Tuesday, September 13, 2022
Medway Planning and Economic Development Board
155 Village Street
Medway, MA 02053
Meeting Minutes

BOUNDARY LANE SUBDIVISION ENDORSEMENT:

We reviewed the Plans titled "Definitive Subdivision Plan, Boundary Lane, A permanent Private Way, Medway, Massachusetts" dated August 20, 2021 with revisions through August 15, 2022 and compared the Plans against Section VII – Conditions of the Certificate of Action dated July 26, 2022. We have the following comments:

SCALE: NONE SHEET 5 OF 6.

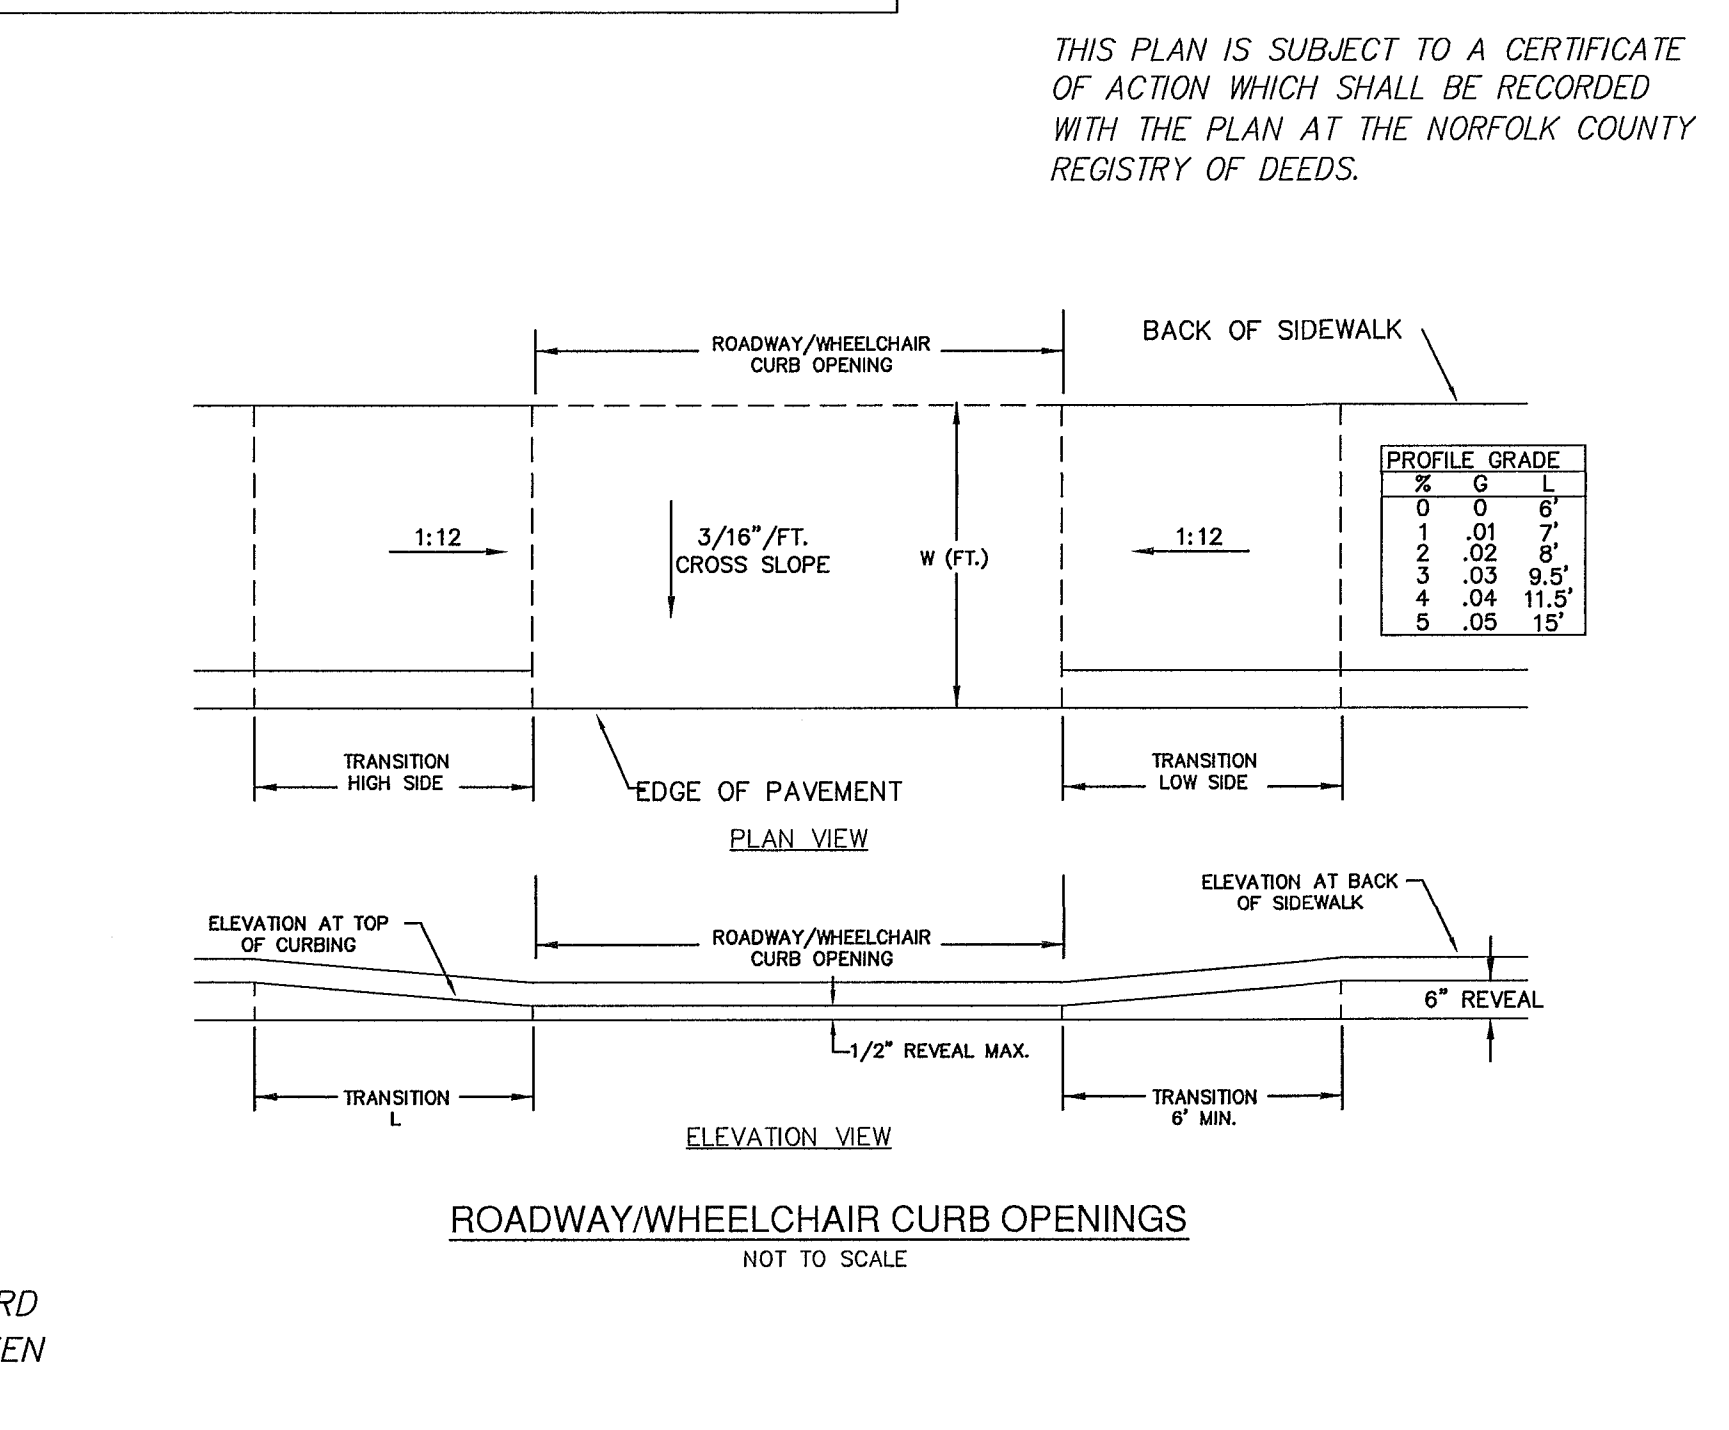
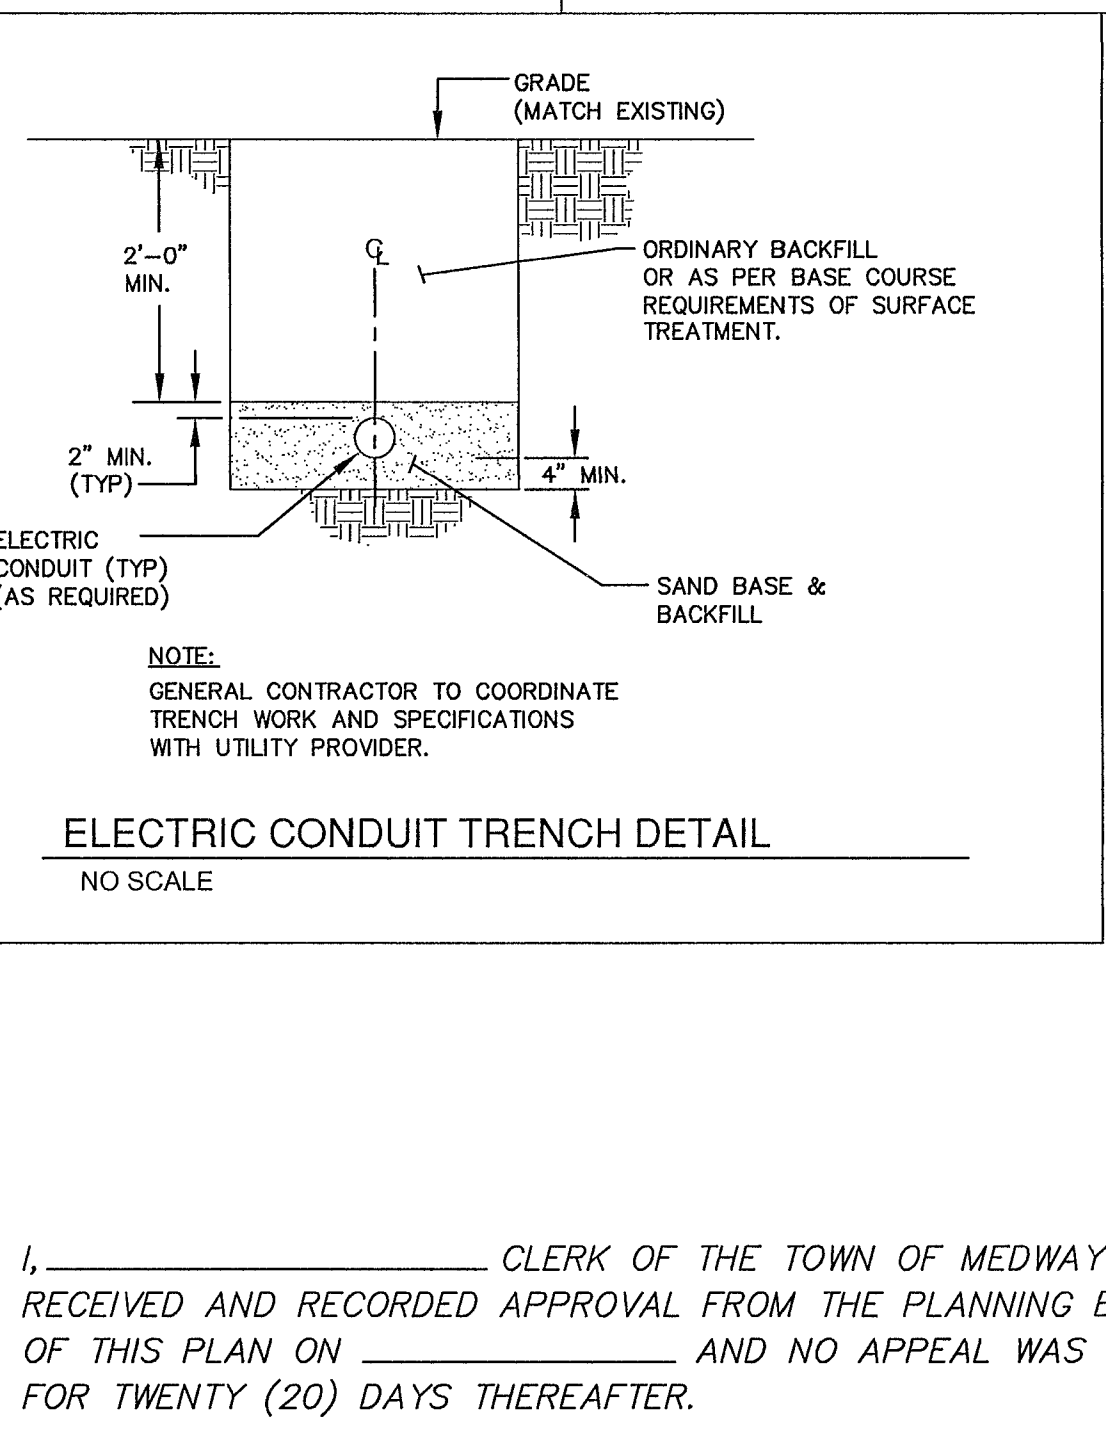
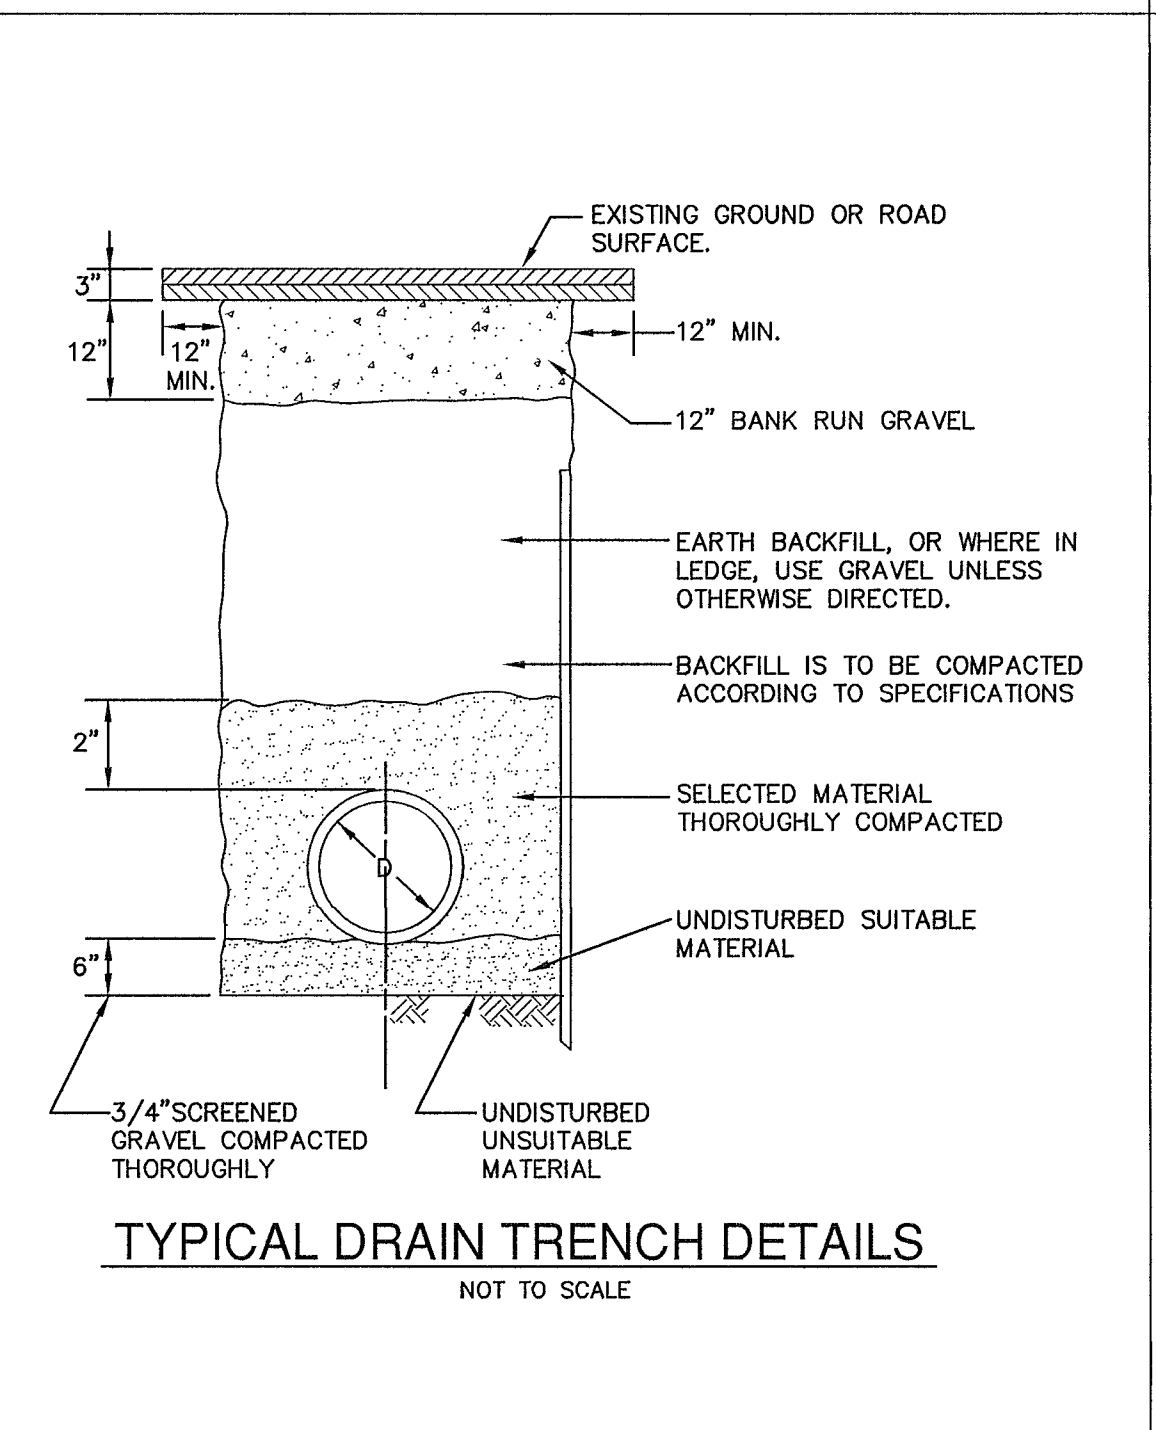
1. The Applicant has included a call-out and plan view for inclusion of ADA ramps at the intersection of the private way and Summer Street. However, a standard detail should be added to the plans to detail construction of the ramp and how it will meet the existing conditions in that area. (§VII.A.3, Bullet 5)

As requested, attached is the revised Sheet 5 with the detail for an ADA transition.

WINGATE FARM DEFINITIVE
SUBDIVISION MODIFICATION
GRADING AND UTILITY
PLAN OF LAND IN
MEDWAY, MA

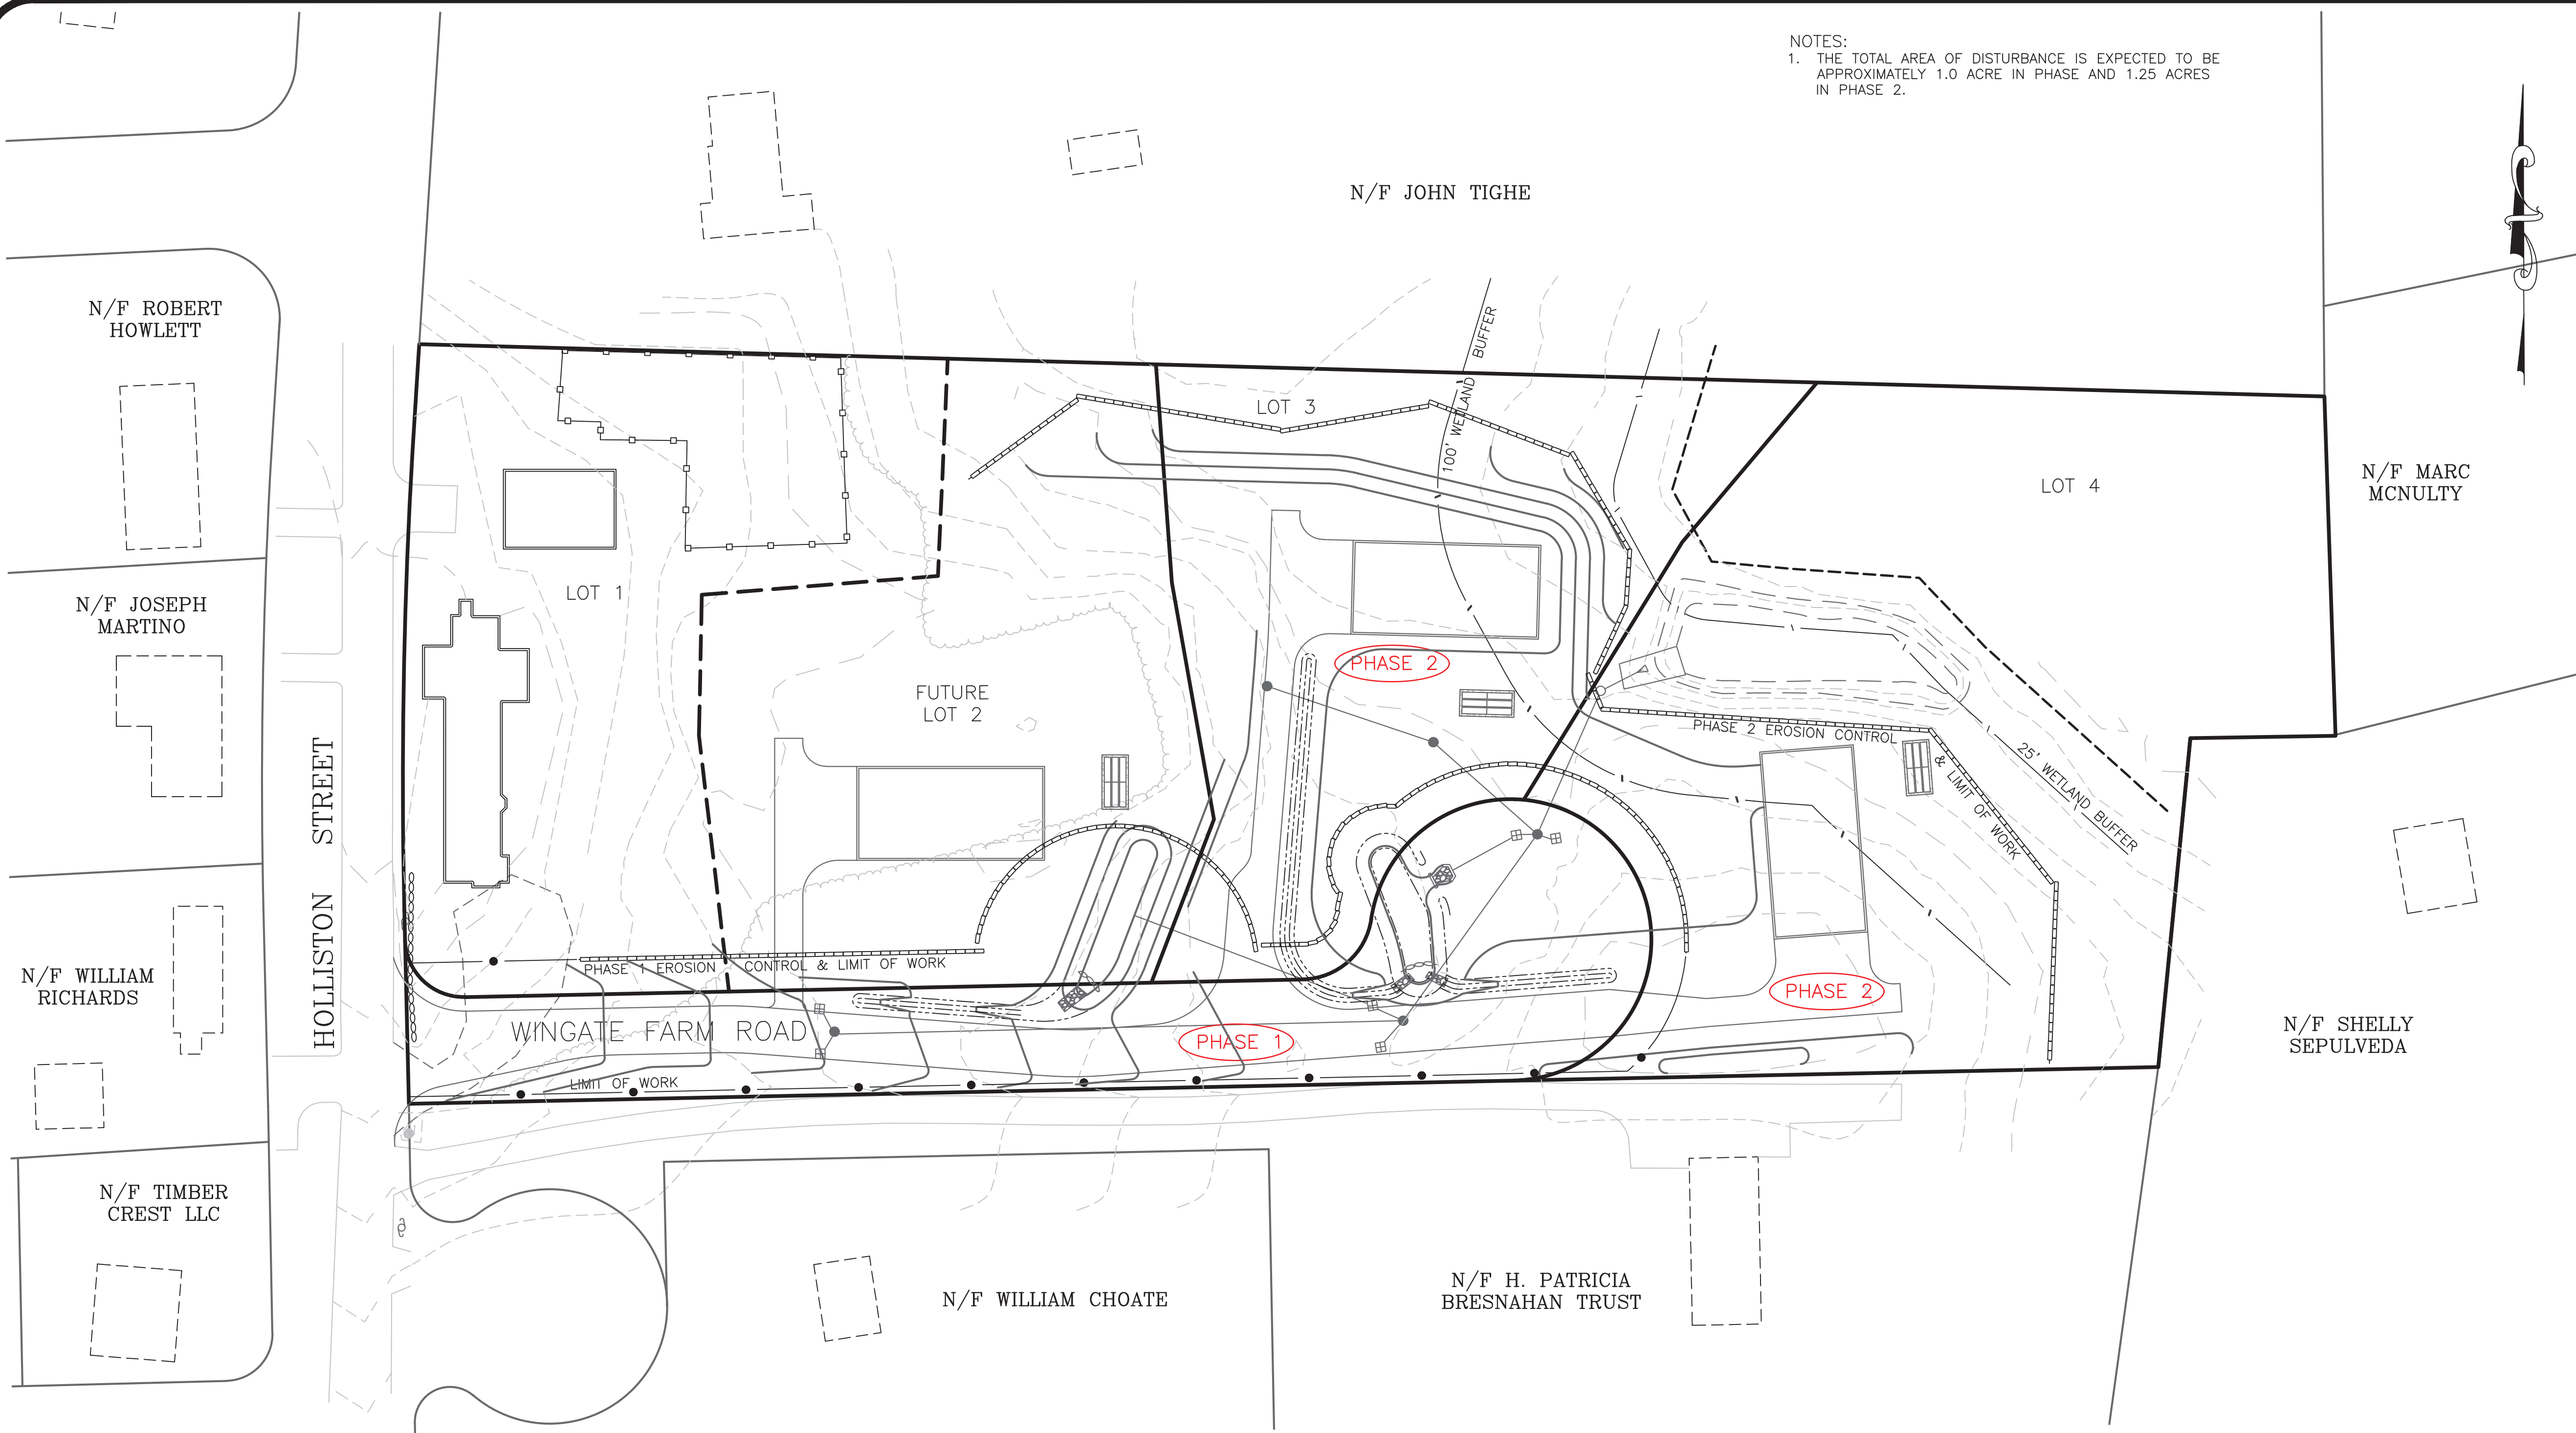
- **TT 9/9/22 Update: In our opinion, this comment is resolved.**
3. Earth fill estimates are not provided in the Plans. (Ch. 200 §204-3.J)
 - *LEL 8/31/22 Response: Earth fill calculations have been added to sheet C-4.*

1. SOIL VOLUMES FOR PHASE 1:
 - 1.1. CUT: 900 C.Y.
 - 1.2. FILL: 750 C.Y.
 - 1.3. TOTAL: 150 C.Y. CUT
2. SOIL VOLUMES FOR PHASE 2:
 - 2.1. CUT: 2,150 C.Y.
 - 2.2. FILL: 1,950 C.Y.
 - 2.3. TOTAL: 200 C.Y. CUT
